Office Action Summary	Application No. 10/803,474	Applicant(s) CHENG, STAN	
	Examiner Philip Gabler	Art Unit 3637

DETAILED ACTION

Nicolai et al. '400 Figures 1, 3, and 7

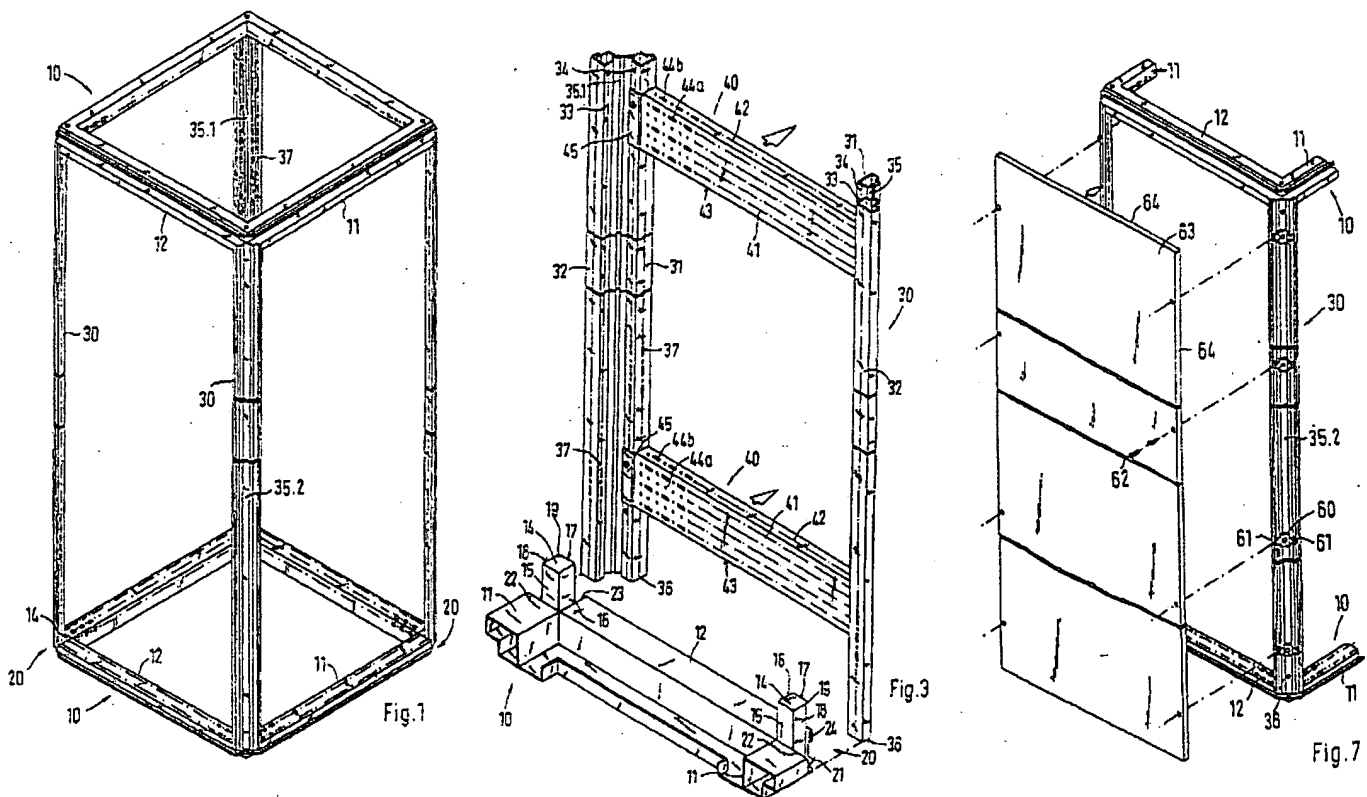
8. Claims 1, 2, 4-6, 9, 10, and 13 are rejected under 35 U.S.C. 102(b) as being anticipated by Nicolai et al. (US Patent Number 6123400).
9. Regarding claims 1, 2, 9, and 13, Nicolai (Figures 1, 3, and 7) discloses a chassis apparatus usable with a computer comprising: a chassis frame (10) comprising a set of load-bearing rails (30) located on edges of the frame; and a plurality of protrusions (box-like protrusions at sides of 30) formed on the load-bearing rails and adapted to support a chassis cover (63) for fitting over and secured to the chassis frame, and to laterally secure a removable structure (40) to the chassis frame in at least two directions by coupling the protrusions with portions (45) of the structure formed to be secured thereover, the removable structure configured to be capable of housing at least one small form factor computer component (see for example column 4 lines 65-67).

10. Regarding claim 4, Nicolai further discloses each protrusion has a flat top surface (viewed as the outer surface abutting the cover) to support the chassis cover.

11. Regarding claims 5 and 6, Nicolai further discloses protrusions which are mounted and integrally formed with the load-bearing rails of the chassis frame.

12. Regarding claim 10, Nicolai further discloses the portions of the structure comprise protrusions corresponding to the protrusions of the chassis frame.

Exhibit 1: Jeong '624 Figures 1 and 4C

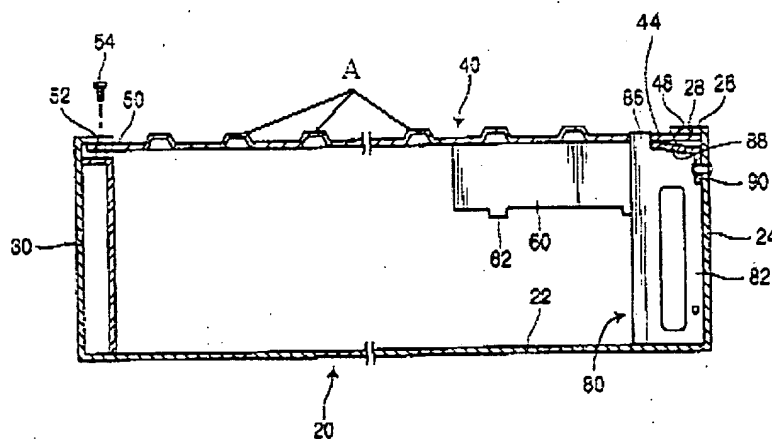
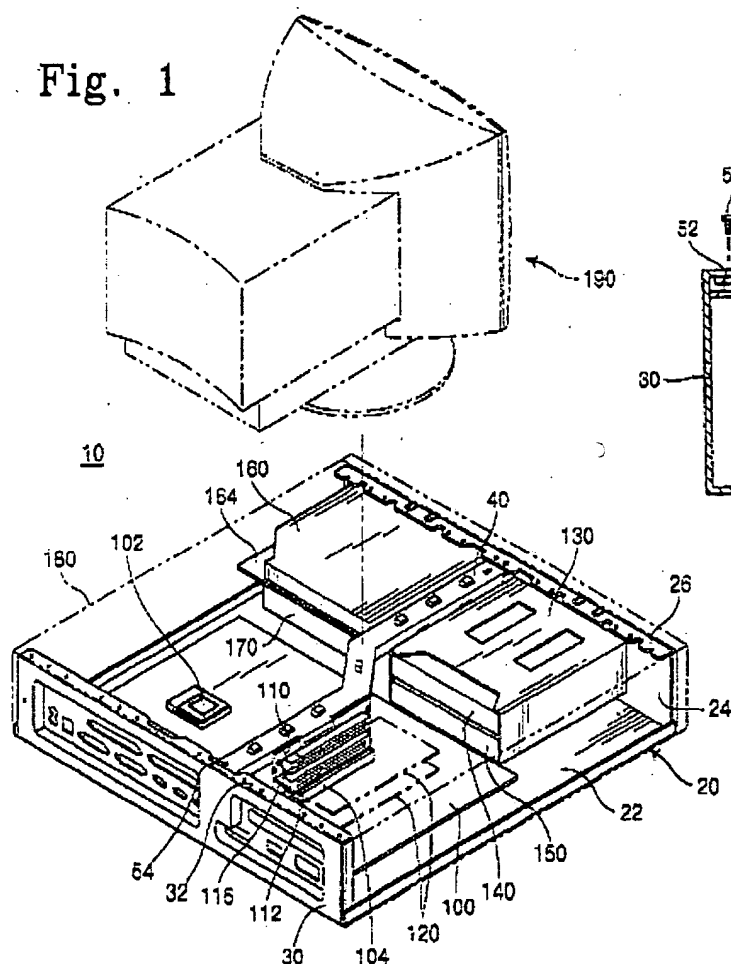
Jeong discloses a computer chassis frame with domes (A) formed on an upward facing surface for supporting a chassis cover. Accordingly, it would have been obvious to one of ordinary skill in the art at the time the invention was made to modify Chang's oblong rounded structures to be domes as taught by Jeong because this arrangement would make installation and removal of the removable drive frame quicker and more simple (the frame could simply be placed on the upward facing surfaces with the interface structures fitting over the domes rather than sliding under hooks) as well as providing better support for the cover.

Chang '886 Figure 1

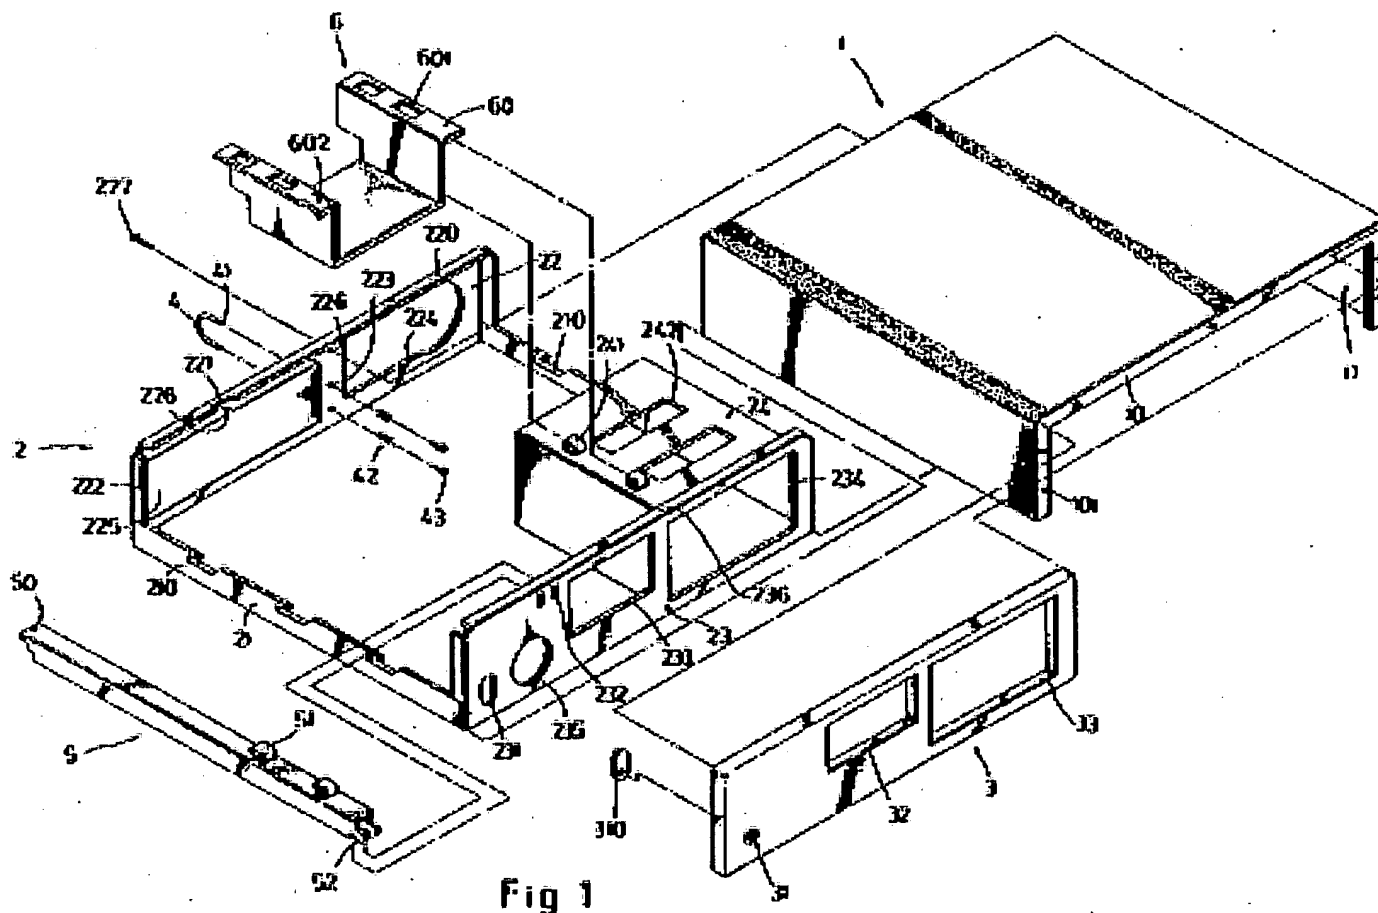
15. Regarding claims 1, 2, 9, and 13, Chang (Figure 1) discloses a chassis apparatus usable with a computer comprising: a chassis frame (2, including 5, 24, etc.) comprising a set of load-bearing rails (5, portions of 24) located on edges of the frame; and a plurality of protrusions (51, 241) formed on the load-bearing rails, and to laterally secure a removable structure (6) to the chassis frame by coupling the protrusions with portions (60) of the structure formed to be secured thereover, the removable structure configured to be capable of housing at least one small form factor computer component (element 6 is a drive holder). Chang does not disclose the protrusions as supporting a chassis cover (which is present as element 1). Jeong (Figures 1 and 4C) discloses a computer chassis apparatus including a load-bearing surface (upper surface of 40) including protrusions, or means for supporting a chassis cover, (viewed as A in Exhibit 1) configured to support a chassis cover (180). [See Figure 4C and column 4 lines 2-7 for disclosure of 40 (and protrusions A) acting as a support for the cover, monitor, etc.] Accordingly, it would have been obvious to one of ordinary skill in the art to replace

18. Regarding claim 10, Chang further discloses the portions of the structure comprise protrusions corresponding to the protrusions of the chassis frame (portions of protrusions 60 mate with the protrusions of the frame).

19. Regarding claim 14, Chang discloses a computer chassis apparatus comprising: a computer chassis frame (2, including 5, 24, etc.) for a form factor computer comprising at least two upward facing surfaces (upper surfaces of 5 and 24); a plurality of oblong rounded structures (51, 241) formed into the upward facing surfaces of the computer chassis frame and distributed along the surfaces; a removable drive frame (6) capable of supporting a plurality of drives of different sizes adapted to be installed within the computer chassis, the removable drive frame comprising interface structures (601) corresponding to each rounded structure. Chang does not disclose domes on the upward facing surfaces for supporting a chassis cover (the cover present as element 1).
